CAIRNGORMS NATIONAL PARK AUTHORITY

Title: REPORT ON CALLED-IN PLANNING APPLICATION

DEVELOPMENT PROPOSED: FULL PLANNING PERMISSION FOR DEMOLITION OF STEADING AND ERECTION OF 3 NO. DWELLINGHOUSES, AT STEADING AND LAND TO THE WEST BOUNDARY OF THE OLD MANSE HOTEL, DUTHIL, CARRBRIDGE

REFERENCE: 06/508/CP

Fig. 5. Site Plan

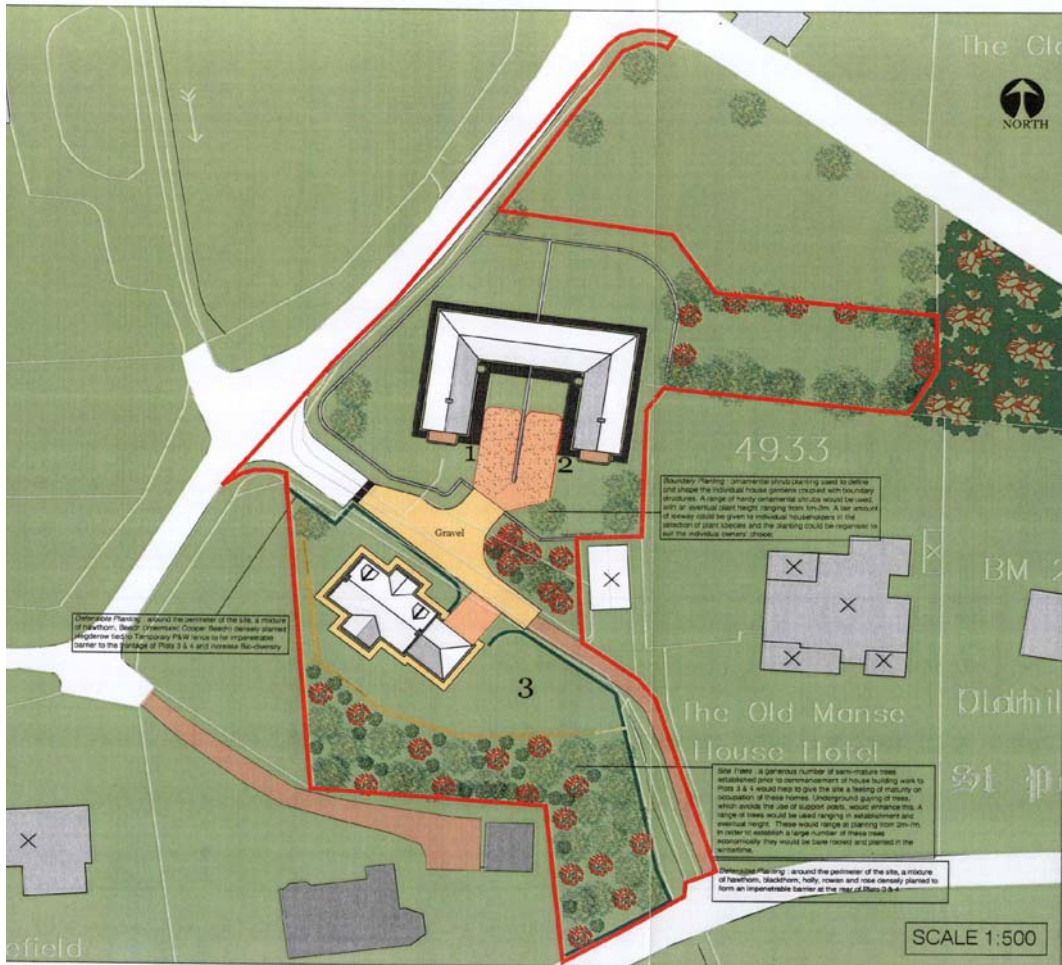
31. There has been concern raised by representees (in particular, the occupants of “Heatherbank”) about the impact of the development on the amenity of other properties in the area. The main concern in this respect has been the proposal for houses on the southern part of the site and the potential removal of the embankment which encloses the north side of “Heatherbank”. After a detailed site assessment and the

submission of detailed site sections and levels, I concurred with the concerns expressed by the owners of "Heatherbank." The majority of the embankment would have been removed, in close proximity to "Heatherbank", and the houses would have had a detrimental impact on the amenity and privacy of that property. They would also have limited the opportunity to provide meaningful landscaping in line with the "Trees and Woodland" policy.

32. The revised proposal for one house positioned as far as possible to the north west side of the plot, with a retaining wall to the garden area, not only allows for more space for structural planting but allows for the retention of the highest part of the embankment and the steeply sloping south facing area down to "Heatherbank". The scale of the house has been reduced to fully one and a half storey and there are now no upper floor windows or elements facing the south. In this way, the amenity of "Heatherbank" is protected.

34. The designs of the buildings are based along traditional lines. The single house plot is of a traditional "country cottage" appearance with dormer windows, skews, vertical proportioned windows, and slate, wet harl and timber finishing materials. The replacement building for the steading, does have a larger footprint and is 700mm higher. However, its scale, character and general appearance is similar. The use of stone walls as boundary enclosures is welcomed.

8. In addition to the landscaping scheme required by Condition No. 7 above, tree planting, of a species and variety, height and number, in accordance with a scheme to be submitted to and approved in writing by the CNPA acting as Planning Authority, prior to the commencement of development on site, shall be undertaken in the embankment and sloping areas hatched in green, on the approved plan drawing no. 1635:100 A. This plan

9. Unless otherwise agreed in writing with the CNPA acting as Planning Authority, the sloping landscaped areas and the embankment, hatched in green on the approved drawing no. 1635:100 A, and referred to in Condition No. 8 above, shall remain, in perpetuity, as an area of structural tree planting, and shall not be incorporated into the functional and useable private garden area of the approved dwellinghouse on Plot 3. For the avoidance of doubt, no ground excavations beyond the retaining wall shown on the approved drawing no. 1635:100 A, shall take place without the further written approval of the CNPA acting as Planning Authority.
